Proposed responses to comments against Clause 91

Adam Healey
LSI Corporation

IEEE P802.3bj Task Force
September 2012

Figure 80–5a—100GBASE-R Skew points with RS-FEC and CAUI

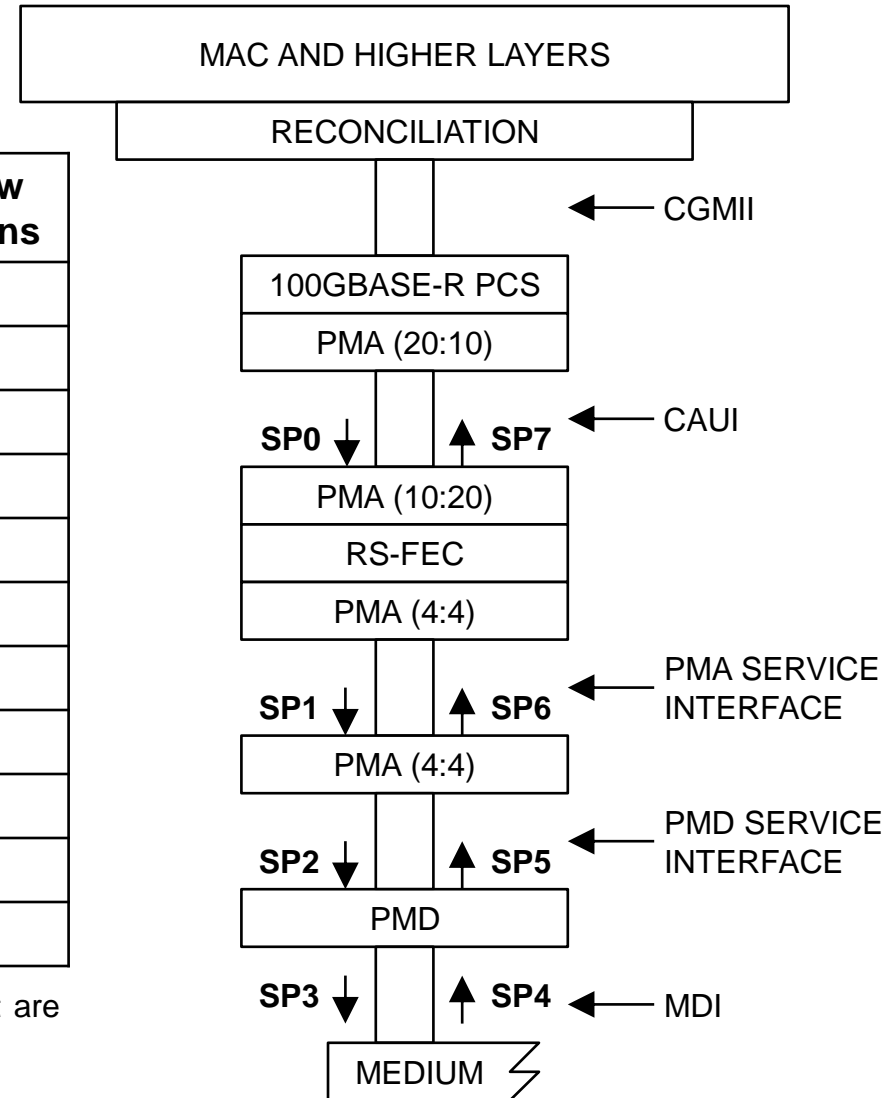
Skew and Skew Variation

Skew point	Maximum Skew ^a , ns	Max. Skew Variation, ns
SP0	29	0.2
SP1	29	0.2
SP2	43	0.4
SP3	54	0.6
SP4	134	3.4
SP5	145	3.6
SP6	160	3.8
SP7	29	0.2
At RS-FEC transmit	49	0.4
At RS-FEC receive	180	4.0
At PCS receive	49	0.4

Figure 80–5a—100GBASE-R Skew points with RS-FEC and CAUI

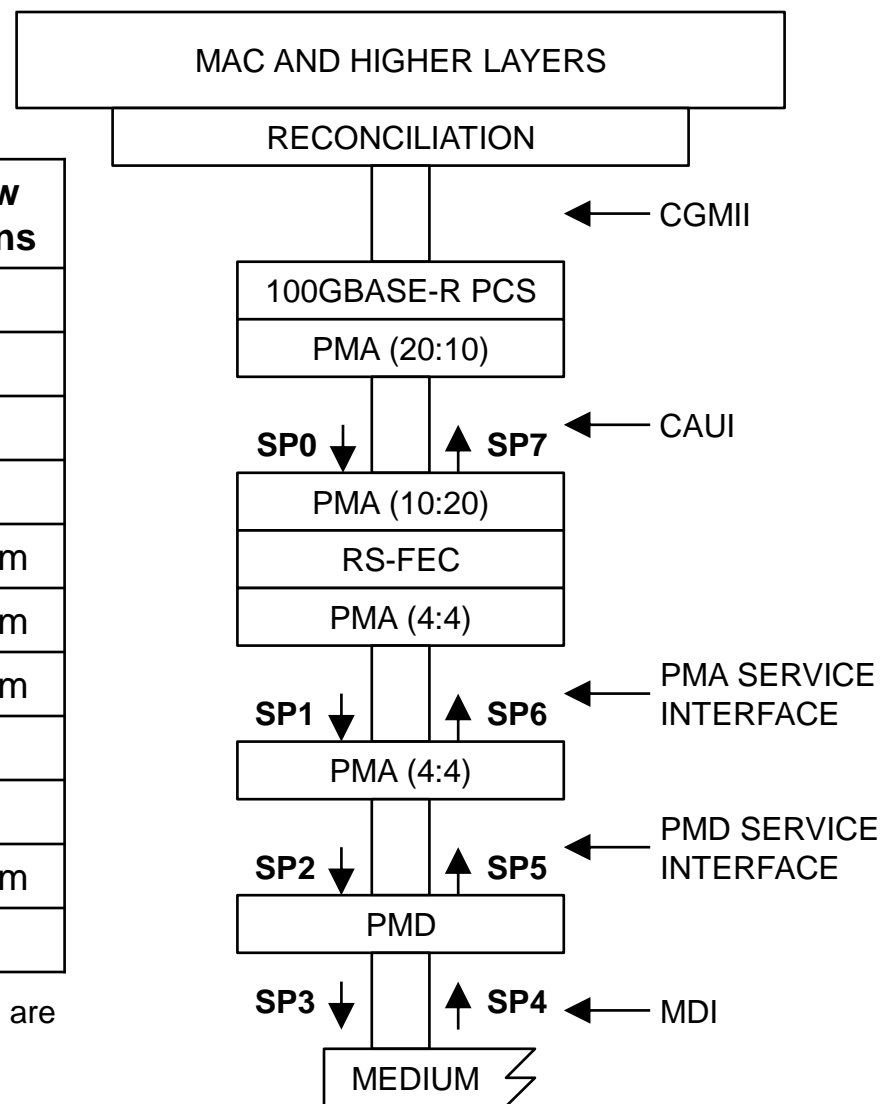
Variable medium allocation

Skew point	Maximum Skew ^a , ns	Max. Skew Variation, ns
SP0	29	0.2
SP1	29	0.2
SP2	43	0.4
SP3	54	0.6
SP4	54+medium	0.6+medium
SP5	65+medium	0.8+medium
SP6	80+medium	1.0+medium
SP7	29	0.2
At RS-FEC transmit	49	0.4
At RS-FEC receive	100+medium	1.2+medium
At PCS receive	49	0.4

- 80 ns Skew and 2.8 ns Skew Variation allocated for medium
- Very generous for some media, e.g. electrical backplane
- Differentiate between “front-panel” and backplane interfaces?
 - Medium Skew 80 ns, Skew Variation 2.8 ns...
 - ...other otherwise noted (backplane PMDs)

FEC/PMA service interface

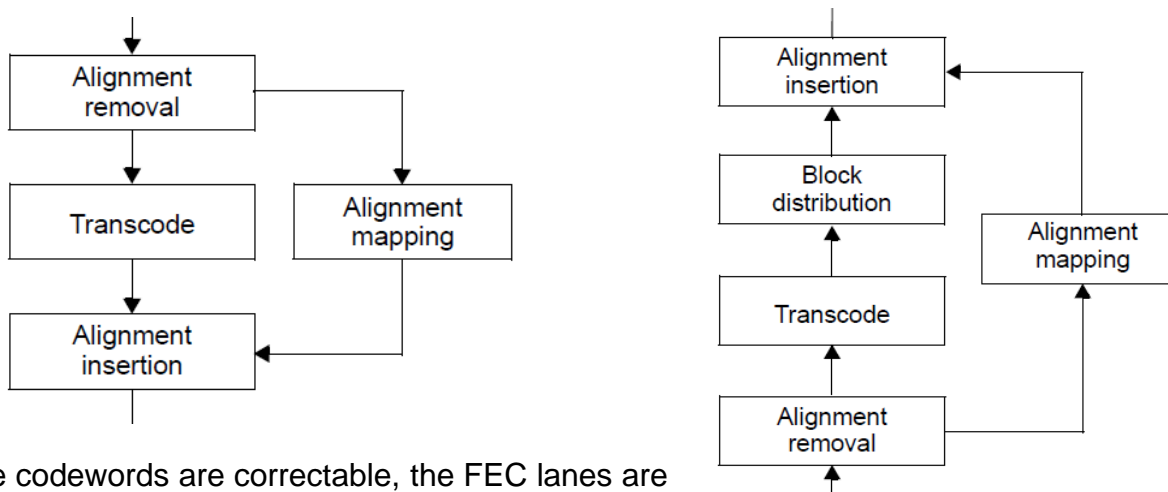
NOTE 1 – Direction reversed by or added by comment #99

NOTE 2 – Direction reversed by or added by comment #100

- RS-FEC defines a special mapping for alignment markers...
- ...and therefore needs to know alignment marker positions
- Positions are learned via the FEC synchronization function...
- ...but those positions are not continuously verified [1]
- Changes in alignment marker positions will not be tracked...
- ...resulting in encoding and decoding errors during LPI

Graphical view

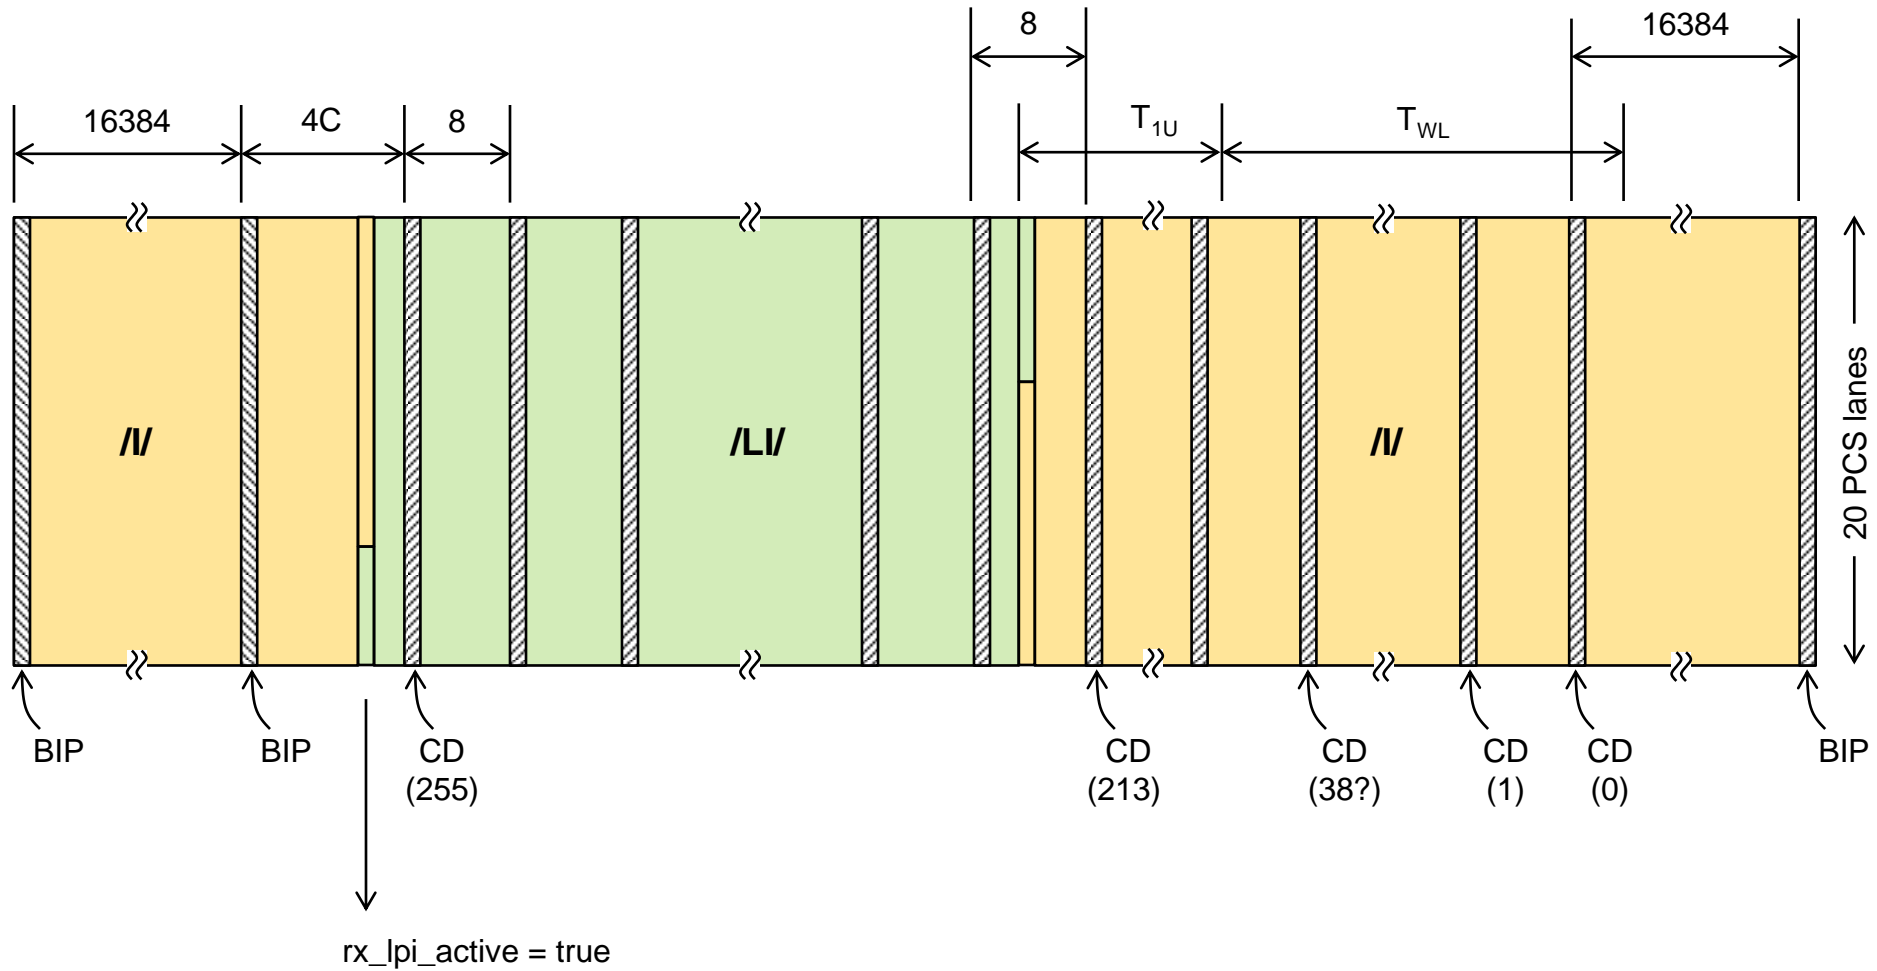
- Transition from rapid to normal coordinated using down_count
- Must coordinate transition from normal to rapid to avoid errors
- Comment #195 suggests that the PCS sends the first RAM...
 - ...after one block of /LI/ appears on PCS lane 0 and...
 - ...when distance from last normal AM is a multiple of 4
- This ensures that...
 - .../LI/ precedes the first RAM and...
 - ...RAMs coincide with the start of an FEC codeword

Proposed Transmit LPI state diagram

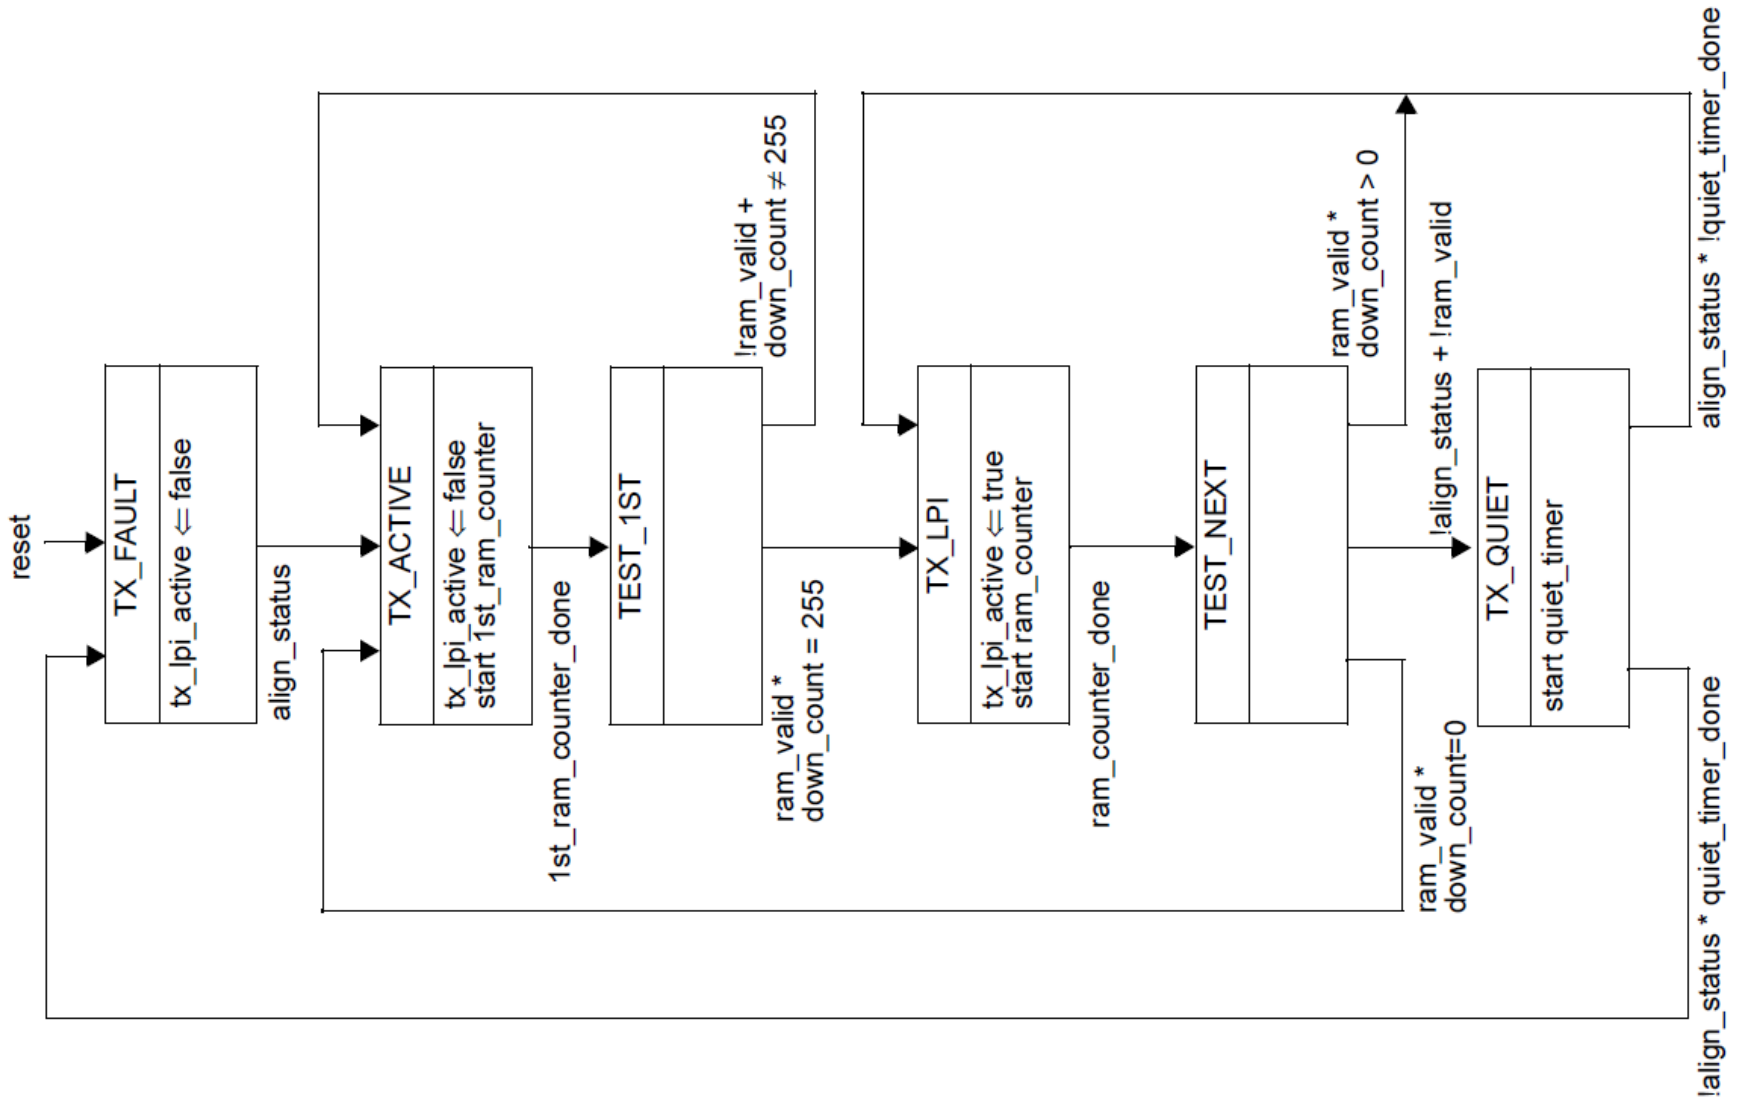
- RS-FEC infers tx_lpi_active and rx_lpi_active
 - Asserted when RAM (down_count=255) detected
 - Only valid positions (per #195) checked
 - Verify across multiple lanes for robustness
 - De-asserted when down_count=0 detected
- When tx_lpi_active (or rx_lpi_active) is asserted...
 - Map RAMs at detected position/intervals
 - Enable rapid synchronization algorithm
- If quiescent mode supported, when tx(rx)_lpi_active asserted
 - Start timer when fec_align_status is deasserted
 - If fec_align_status reasserted before timer fails, no change
 - Otherwise, tx(rx)_lpi_active deasserted (link disconnected)
